# **Responses to FERC Additional Information Request OP-1(g) (Operational Scenarios)**

Hells Canyon Project  
FERC No. P-1971-079

Idaho Power Company

February 2005

Figure 2a. Historically observed and modeled scenario-specific flows from Hells Canyon Dam during a moderate inflow year, 1995.

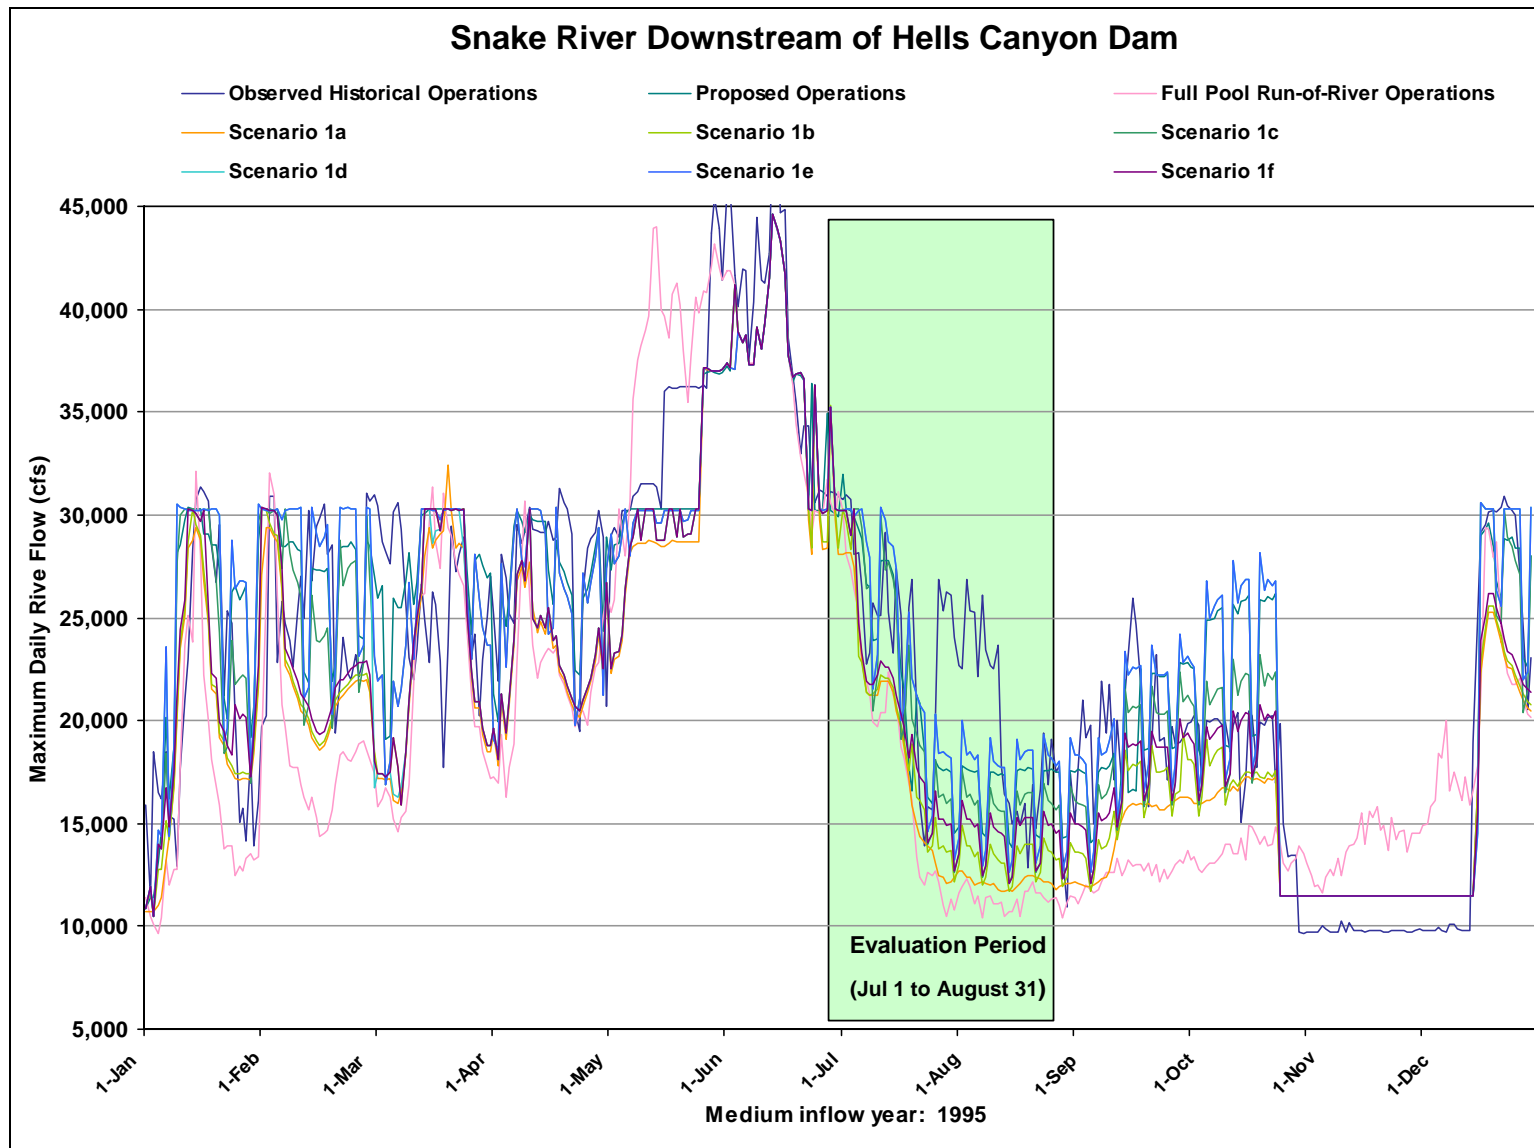
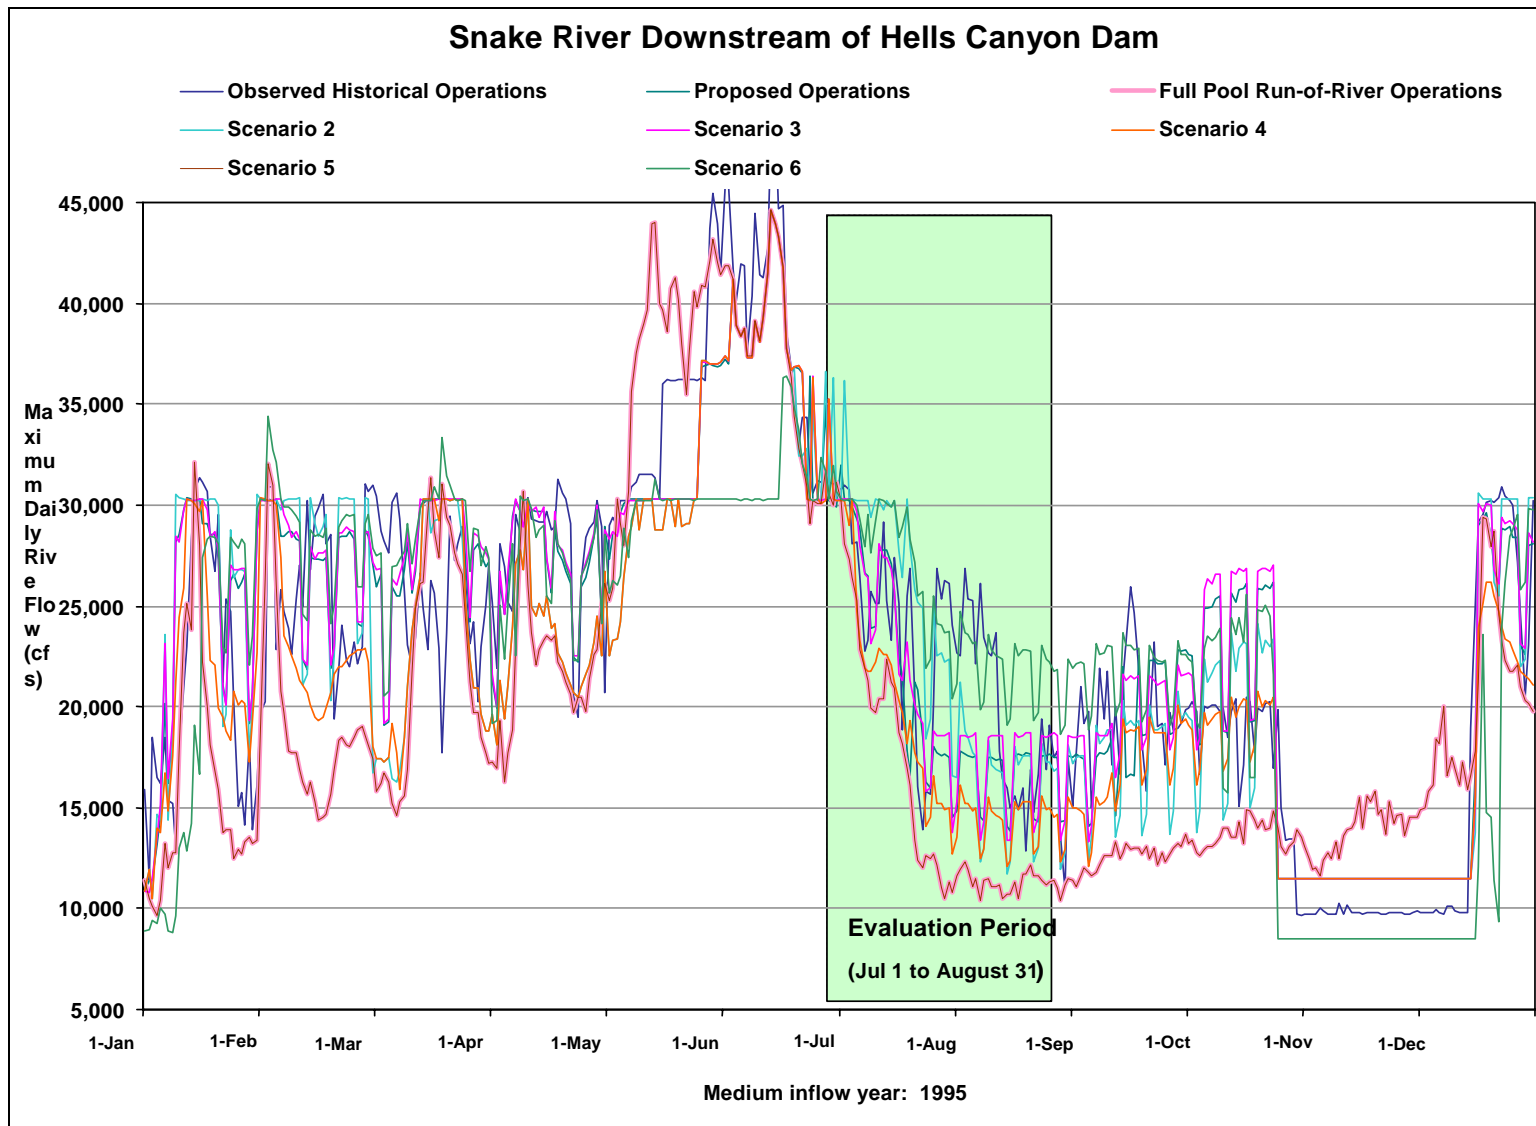
If pictures portray a thousand words, then Figures 2a and 2b don't say much. They are too busy to provide meaningful information. Data should be displayed with only a couple of scenarios per graph.

Figures 2a and 2b are too busy to provide the reviewer an opportunity to make any meaningful comparisons. Data should be displayed with only a couple of scenarios per graph.
